Planning Decisions Committee

6.30pm, Tuesday 24 October 2023

1. This report provides the Planning Decisions Committee with an assessment of planning permit application PLN22/0941 which is for the construction and use of the land for 7 townhouses and an associated reduction in the car parking requirements of the Yarra Planning Scheme.

Ward:	Langridge
Proposal:	Construction and use of the land for 7 townhouses and an associated reduction in the car parking requirements of the Yarra Planning Scheme
Existing use:	Warehouse and vacant block
Applicant:	93 Sackville St Collingwood Pty Ltd
Zoning / Overlays:	Commercial 1 Zone Design and Development Overlay – Schedule DDO15-1D Environmental Audit Overlay Special Building Overlay Development Contributions Plan Overlay – Schedule 1
Date of Application:	12 December 2022
Application Number:	PLN22/0941

Figure 11: Urban Design mark-up of ground floor plan showing indicative landscaping along the laneway (in green)

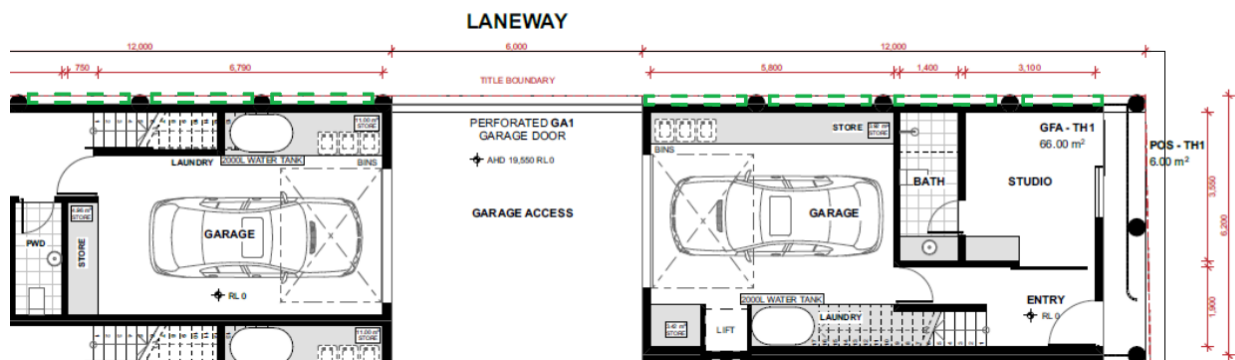
164. Council's Urban Design unit has recommended the provision of additional greenery along the laneway interface of the development to enhance the public realm and also discourage graffiti. This could be achieved by the introduction of cut-outs in the western boundary wall to accommodate a creeping plant as shown in the following image. This would also match the cut-outs provided along Sackville Street.

Figure 13: DDO15 upper level setback on Section A

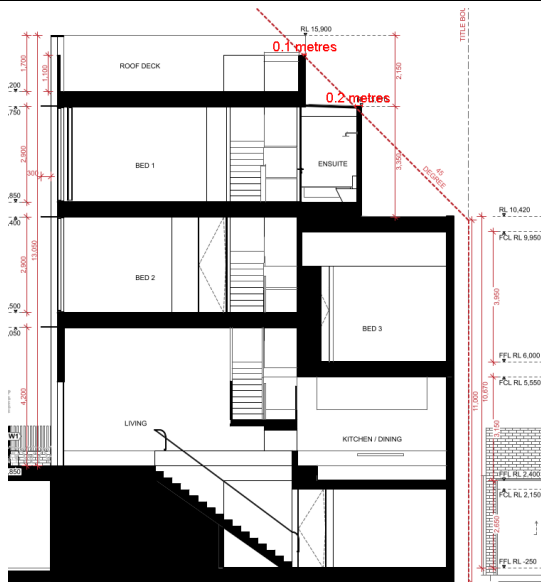
179. For upper level setbacks, DDO15 prescribes a minimum front and rear upper level setback of 45 degrees above 11m. The non-compliance with the 11m street wall height has already been discussed, and the upper level setback from Sackville Street will be greater than 45 degrees given these levels are set back more than 15m from Sackville Street. The applicant submitted a revised Section A (Drawing DA3.1) showing the preferred upper level setback footprint for the rear of the development, shown in the following image:

Figure 14: Mark-up of proposed roof terrace plan showing setbacks of development from private open space at No. 10 Gold Street

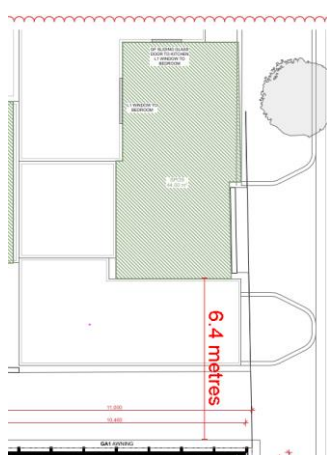
186. It is further noted that the dwelling is located within the C1Z and is not afforded the same amenity expectations as dwellings in residentially zoned land, as has been discussed in the Strategic and Policy Support section of this report. In addition, existing use rights as a dwelling has not been established for No. 10 Gold Street.

Figure 15: Proposed site plan showing location of SPOS (in green) at No. 140 Johnston Street

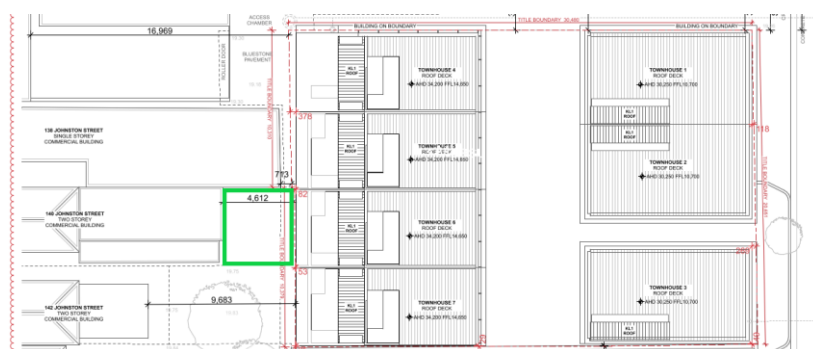
187. The southern boundary wall height will vary between 7.5m up to 16.6m. Buildings to the south of the subject site, on Johnston Street are primarily commercial, with the exception of No. 140 Johnston Street, a two storey dwelling with private open space at the rear of the site. It is noted that the development plans incorrectly reference this property as a commercial building. Planning permit PLN20/0105 was approved on 31 July 2020 for an extension to the existing building at No. 140 Johnston Street and recognises this building as having existing use rights as a dwelling. The location of this SPOS is shown in the following image. Notwithstanding, this dwelling is also located within the C1Z and is surrounded by commercial uses to its east and west. As previously discussed, amenity expectations for dwellings in commercially-zoned land ought to be tempered in order to minimise land use conflict in locations where higher density development as well as commercial uses are encouraged.

Figure 16: Planning officer shadow study of a 3.6m high southern boundary wall

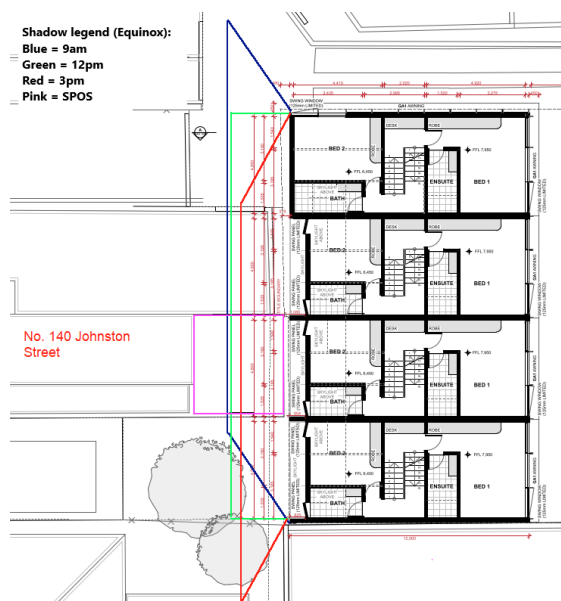
189. The proposed 7.6m high boundary wall opposite this SPOS is acceptable. Had the height of this wall been reduced to comply with the Standard (e.g. a maximum of 3.6m), this SPOS would still be substantially overshadowed by the proposed development. This has been illustrated in the following shadow study prepared by the Planning Officer in *Objective Trapeze*. The shadow studies were undertaken for the September Equinox in accordance with Standard B21 (Overshadowing) of Clause 55. The following diagram has not accounted for shadows cast by existing built form to the east and west of No. 140 Johnston Street. As such, the extent of overshadowing during the morning and afternoon would be greater than what is illustrated in this diagram.

Figure 17: Planning officer mark-up of Section A showing Standard B22 view line from southern roof terraces

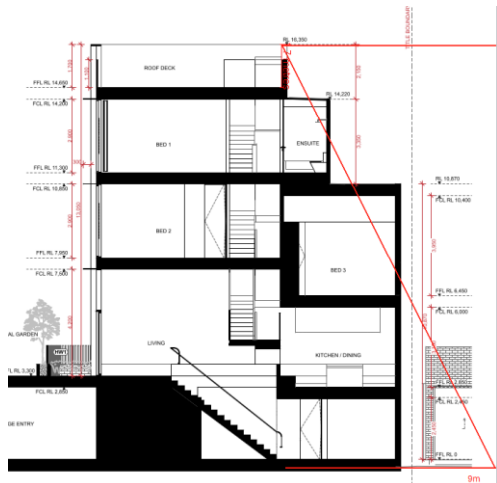
206. The proposed fourth floor roof terraces will be set back a minimum 4.509m from the southern boundary and will be constructed with a 1.2m high solid wall along the southern perimeter. The SPOS of No. 140 Johnston Street is located within a 9m radius of the roof decks of Dwellings TH05 – TH07 only.
207. Applying the Standard, the following mark-up of Section A shows that views to the SPOS of No. 140 Johnston Street from the southern perimeter of these roof terraces would be obstructed by the built form of lower levels. As such, there will be no unreasonable, direct views into this SPOS. The objective is therefore met.

Figure 18: Planning officer mark-up of Section A showing view line between roof terraces

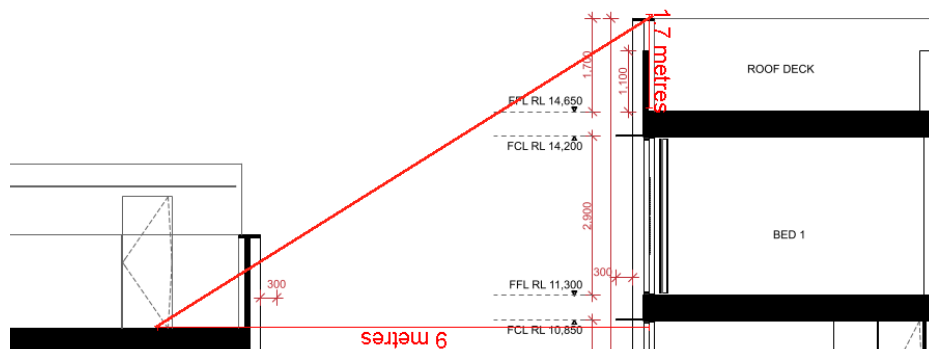
212. The southern perimeters of the roof terraces to Dwellings TH01 – TH03 will have metal mesh screens up to 1.7m above terrace floor level, with a maximum transparency of 25% in accordance with Standard B23. The northern perimeter of the roof terraces to Dwellings TH04 – TH05 will have metal mesh screens up to 1.1m above terrace floor level and will reasonably limit views to the roof terraces of Dwellings TH01 – TH03 as shown in the planning officer's mark-up of Section A below:

Figure 1 – Dashed green line - potential greenery addition proposal (indicative). Not to scale.

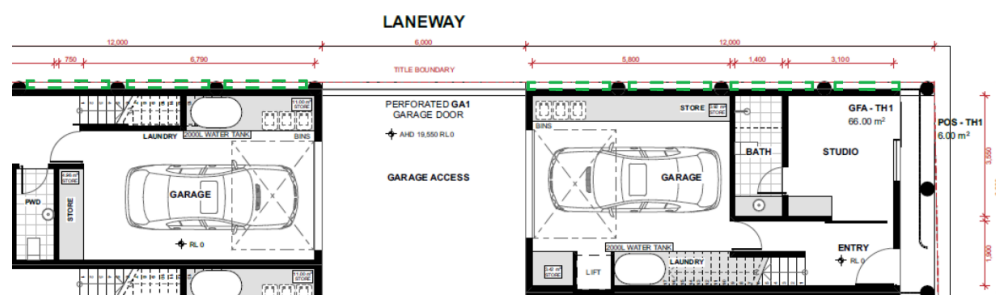
- The proposal provides vehicle access from laneway which is supported from an urban design perspective and meets the vehicle access and car parking guidelines specified in DDO15. The boundary wall along the laneway includes large expanses of brick wall, and there is an opportunity to provide more greening to improve the amenity of the laneway and prevent graffiti on this wall. This could be achieved through providing cut-outs alongside the boundary wall (where the wall is inset and there is a small strip within the property boundary) to accommodate a creeping plant and match the planting proposed in the cut-outs alongside Sackville Street. This should be detailed in an updated Landscape Plan and referred to Open Space Services (Design).

Figure 2 -Additional Street Tree and car parking proposal (indicative). Not to scale

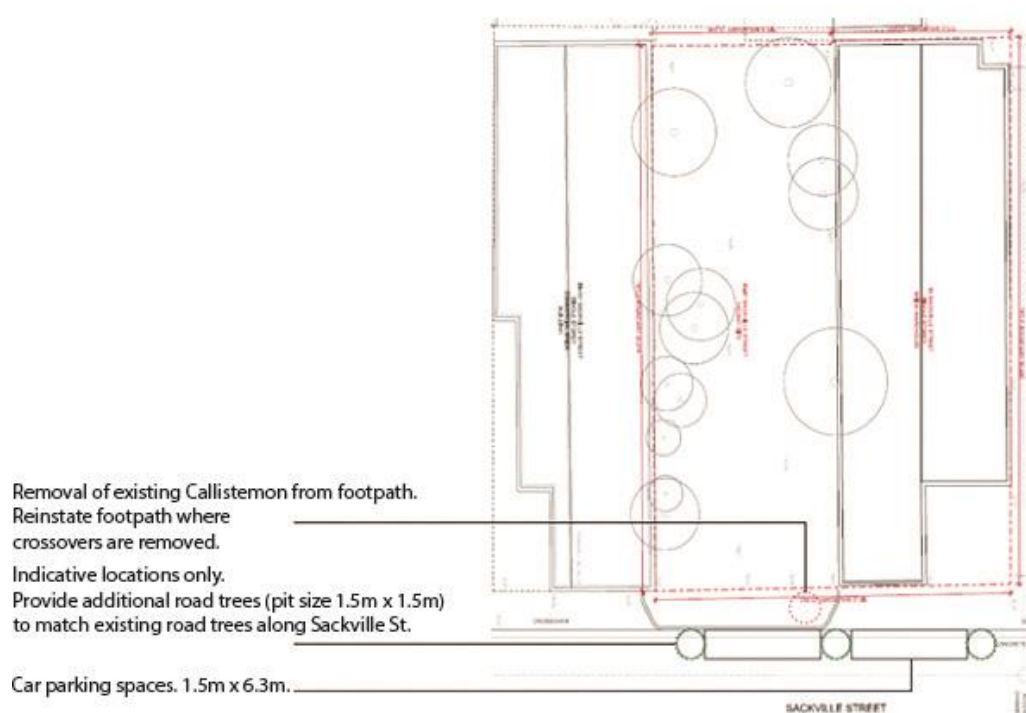
- The development removes a number of trees within the site. The tree removal should be referred to the Open Space Services team.
- Due to the loss of trees within the site and the inevitable changes to the existing crossovers, it is recommended to increase street tree planting along the site's Sackville Street frontage. The developer is requested to fund the planting of 2 new street trees along Sackville Street in the indicative locations, shown in Figure 1 below, noting the following:
